ROVER PIPELINE
An ENERGY TRANSFER Company

Re: OEP/DG2E/Gas Branch 4
Rover Pipeline LLC (Rover Pipeline Project)
FERC Docket No. CP15-93-000
Response to J.D. Hair Report and FERC Letter Orders

Figure 1 – Grid Overlay

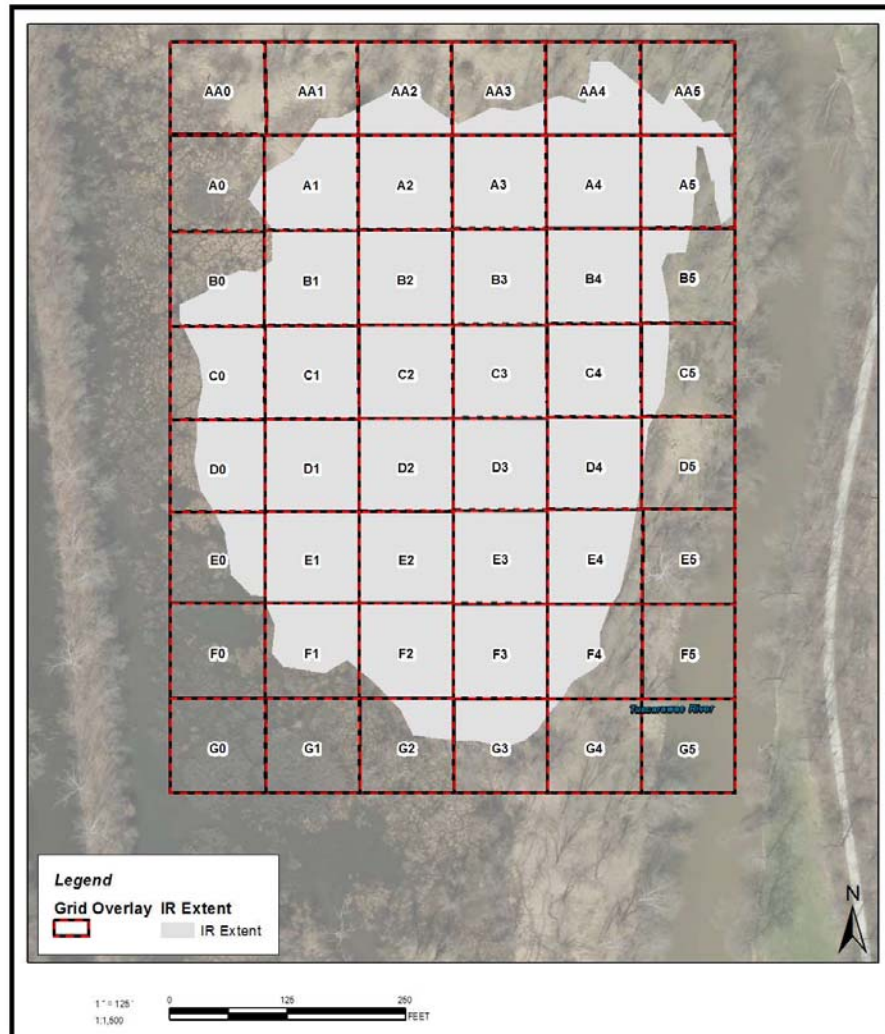
To be clear, Rover’s testing did confirm the presence of small amounts of diesel in and around Grid A3 and Grid C1/D1 (see Figure 1). This data alone, however, does not demonstrate that diesel fluid (or other petroleum hydrocarbons) entered the slurry as part of the HDD process, or that there was a widespread impact. Rather, this testing data is equally consistent with a limited, low-volume release in and around samples collected within the center of Grid A3. Rover theorizes that these diesel concentrations could have been caused by an inadvertent and unreported spill or leak from equipment operating during the clean-up of the IR, or it could have been the deliberate or malicious act of individuals opposed to the project. Given the extensive inspection and oversight at this and other sites along the project, it is difficult to imagine that this occurred from an unreported spill or

leak. Nonetheless, Rover is deeply troubled by any of these potential scenarios and has taken steps to address these possible sources.

First, with respect to the possibility of an unreported spill during cleanup, Rover will reiterate to all employees and contractors that all construction must adhere to the requirements of its FERC certificate, the *Spill Prevention and Response Procedures* and the *Project Specific Wetland and Waterbody Construction and Mitigation Measures*, both of which were approved by FERC prior to the commencement of construction. These construction plans require secondary containment for equipment working within or near wetlands and waterbodies, and require the prompt notification following a spill of hazardous materials. While Rover has no evidence that the diesel was the result of a spill or failed containment, it will remind its employees and contractors of these requirements to reassert their importance.

Second, with respect to the possibility that someone introduced diesel into the mud at the IR site for malicious purposes, Rover has hired security to oversee the Tuscarawas HDD site and has increased scrutiny of all personnel entering and leaving all HDD sites.

Third, Rover has committed to having a third-party engineer on-site at each of the proposed drills to oversee the drilling operations. In addition, Rover will employ an HDD Inspector to be present on all HDD sites to oversee management of the site during each shift at locations where drilling will operate 24 hours a day. This personnel, as well as Environmental Inspectors along each construction spread, will be present and accountable to report any occurrences observed that may be inconsistent with the construction plans and commitments made to the relevant agencies.

Finally, in the event there is some other possible source Rover has not yet considered, Rover has also submitted a *Horizontal Direction Drill (HDD) Sampling Plan* to OEP staff and the Ohio EPA for the testing of slurry in all HDDs in Ohio for petroleum hydrocarbons. If such testing returns positive results, Rover will conduct testing to determine, if possible, the source of those hydrocarbons.
